TENNESSEE VALLEY AUTHORITY

ENCLOSURE  
WATTS BAR NUCLEAR PLANT UNITS 1 AND 2  
BULLETIN 80-06

Question 31.147

Engineered Safety Features (ESF) Reset Controls (IE Bulletin 80-06)

FIGURE 31.147-8

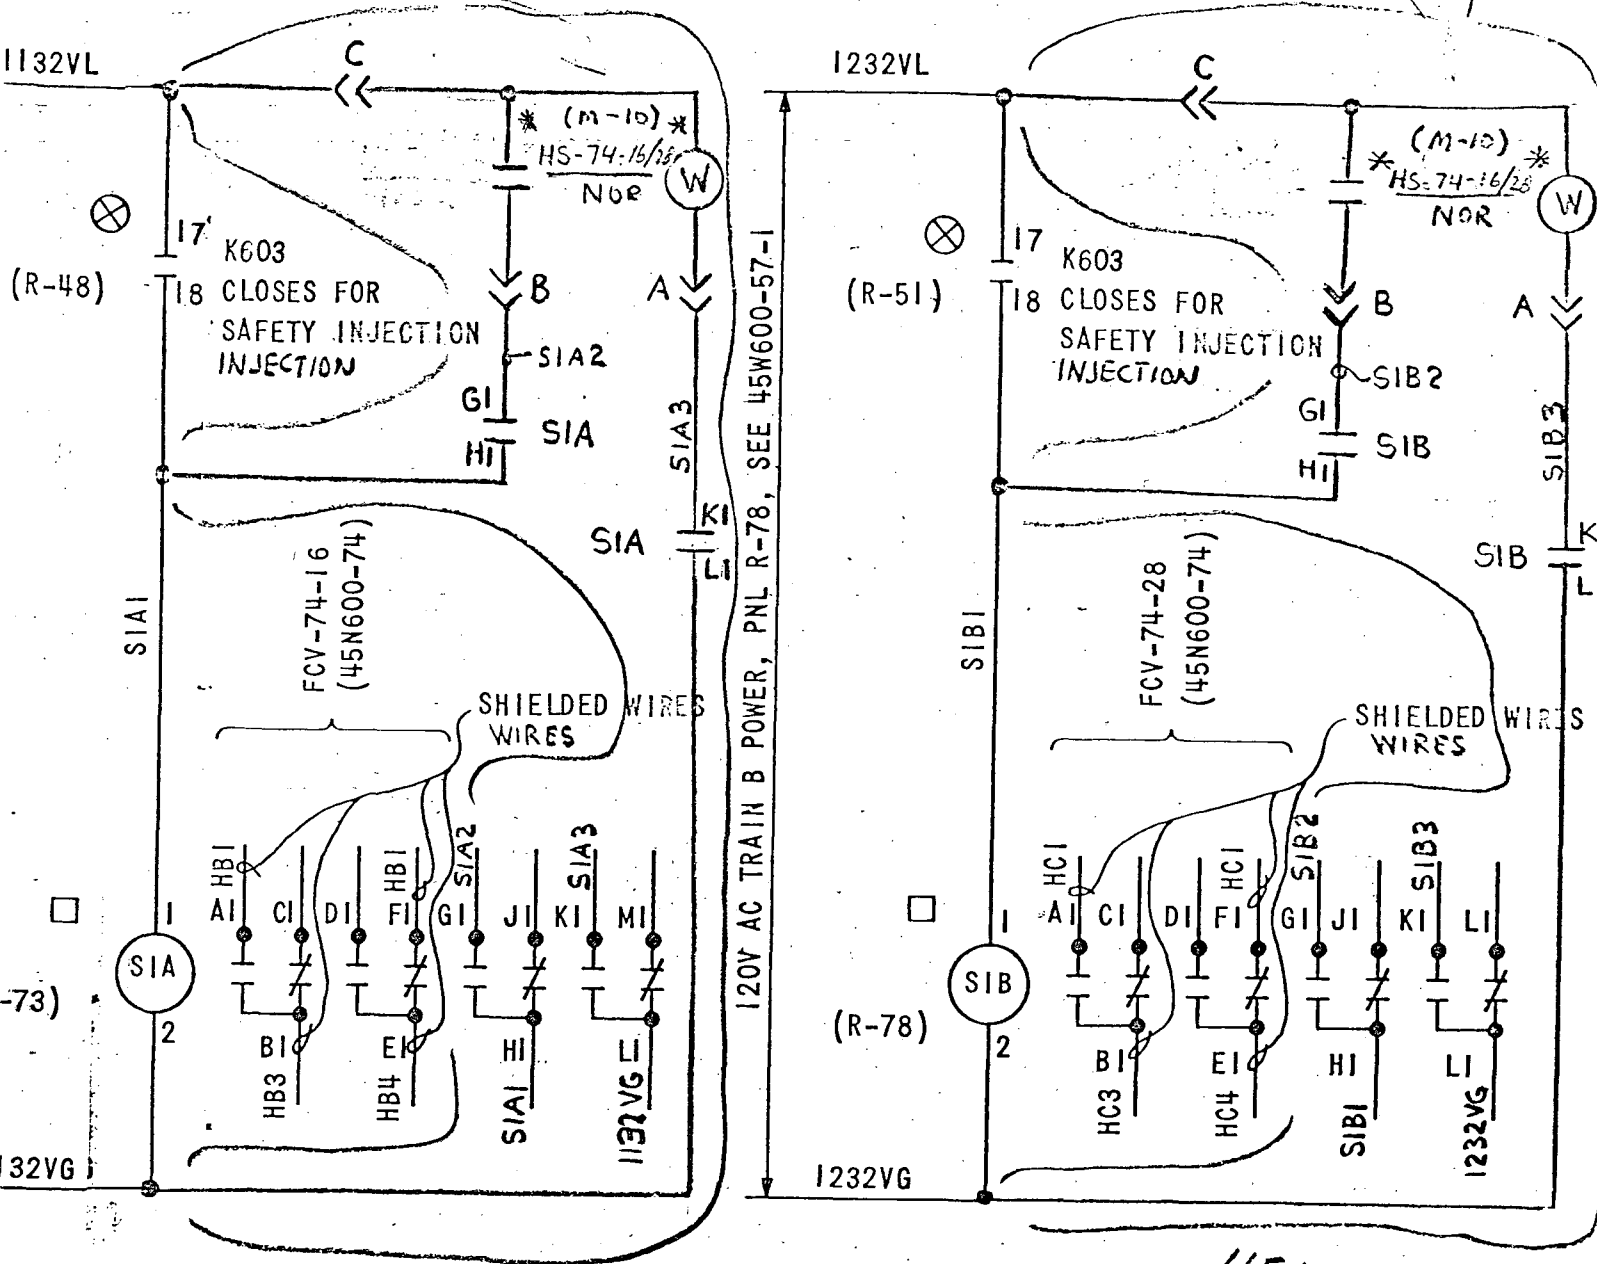
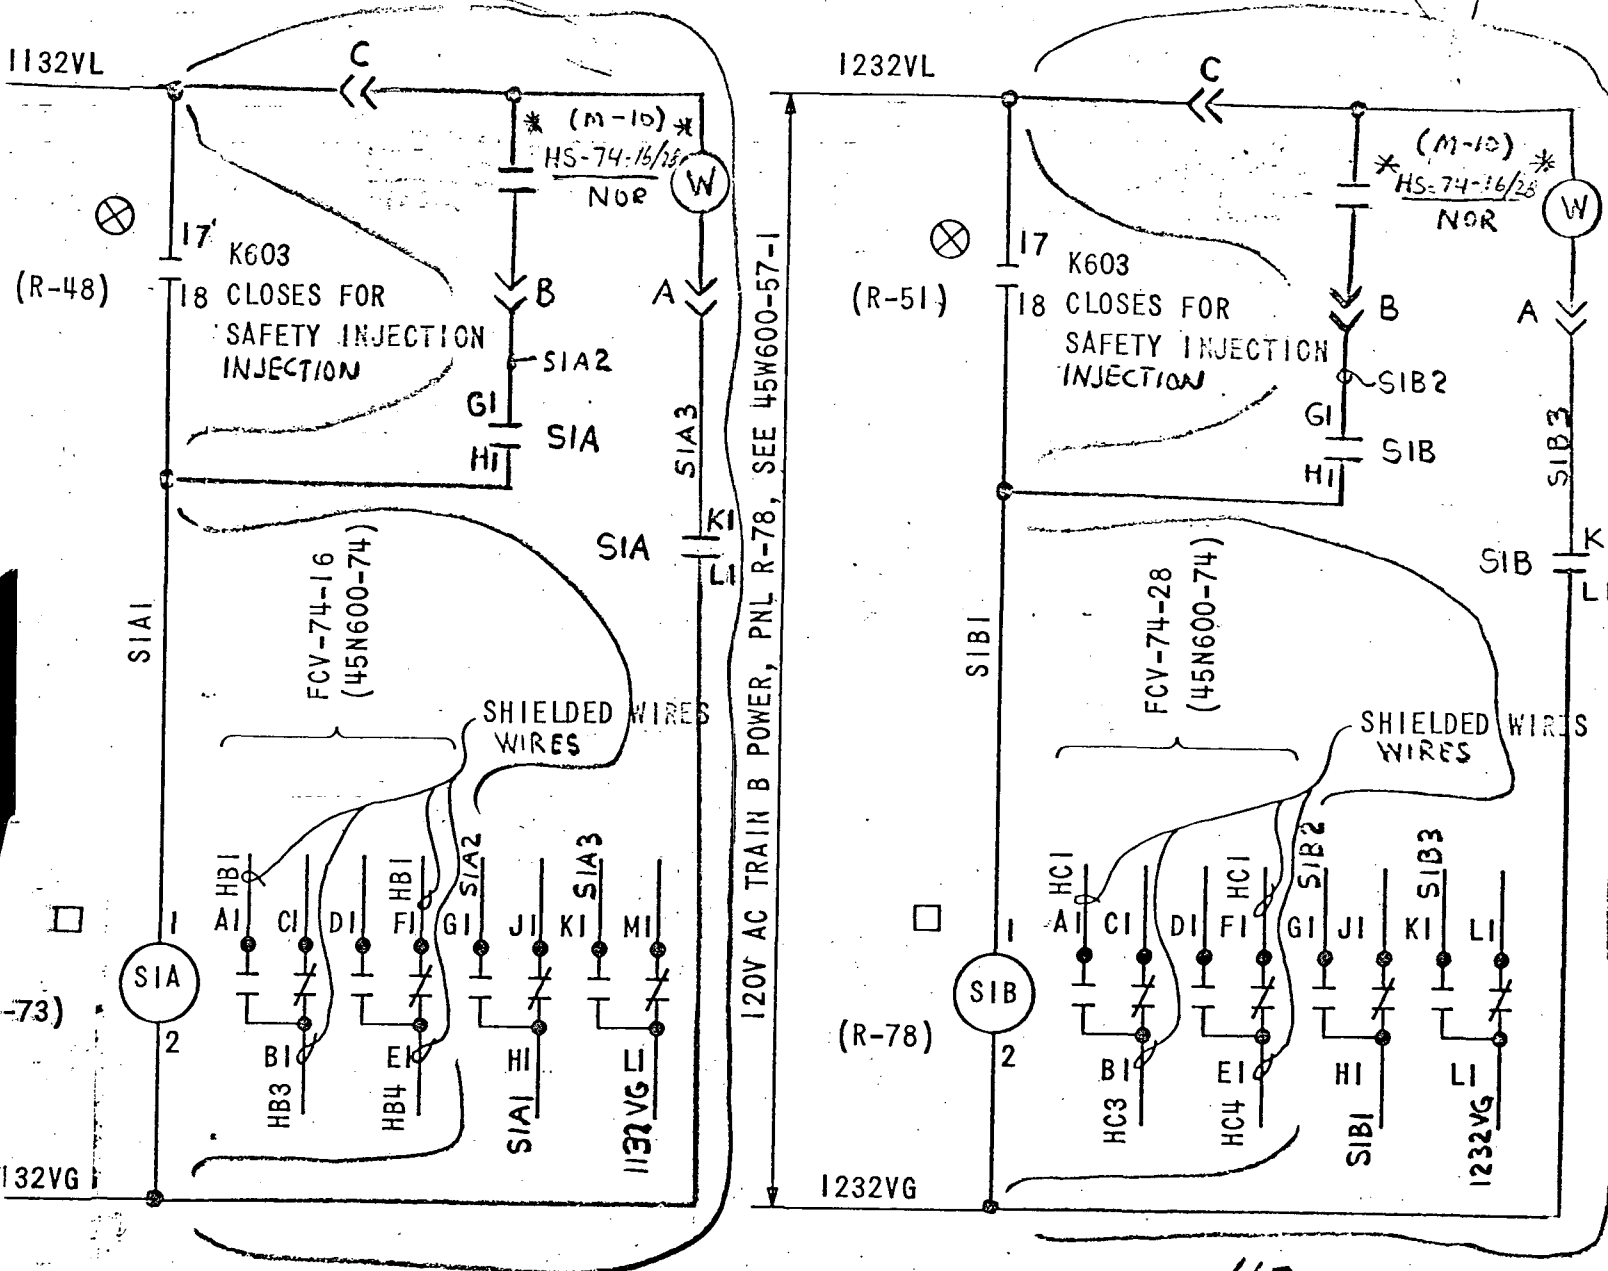
The following is a list of safety-related equipment which was identified as not remaining in its emergency mode. The equipment was evaluated and determined to impact the safety of the plant or the ability to achieve and maintain safe shutdown. Design changes have been initiated for this equipment. Modifications will be completed before fuel loading.

FCV-74s will also use a limit switch to seal in the ESF signal and a new reset switch to individually reset the FCV. The new reset switch is located in the control room. See figure 31.147-8.

3	2936		REC															
ADD RESET-SEAL IN FOR FCV-74-16 & FCV-74-28 AUX RELAYS																		
2	1549	7-20-78	RLS	KAL	TEB	JWB	LINE											RL HG
REV 605B1 & 605B2.																		
1	1387, SI	9-27-77	RLS	KL	WKS	JWB	gxx											HG
1387: THIS IS A REDRAW. DELETE BVAR, BVBR+BVCR. SI: REV 605A1, 605A2, 605B1, 605B2, AFC, AFA, AFB, BVA+BVB, DELETE 605X1, 605X2, BVC+BVD. REV. NOTES.																		
REV	ECN NO.	DATE	DSGN	DRWN	CHKD	SUPV	ENGR	INSP	SURV	DECU	APPN
